# Service Bulletin

Bulletin No.: 16-NA-185

**Subject:** Information on Front Lower Air Dam

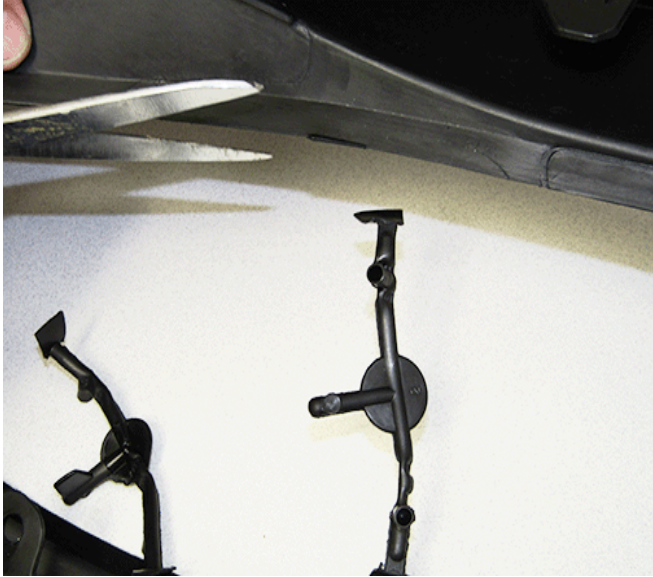
<b>Condition</b>	The two piece front lower air dams are placed in the vehicles trunk at the assembly plant and installed at the dealership during PDI. They were originally separate left and right side parts, but dealers will begin seeing the two halves connected.
<b>Cause</b>	 <p>4498061</p> <p>As an error-proofing measure to ensure the left and right halves arrive properly, the two pieces now are attached to each other.</p>

Before installation of the air dam, it will now be necessary to cut the two halves apart, removing the excess plastic.

Using scissors, or a similar cutting tool, cut the six flat tabs at the part edge and trim any excess plastic as close to the edge as possible.
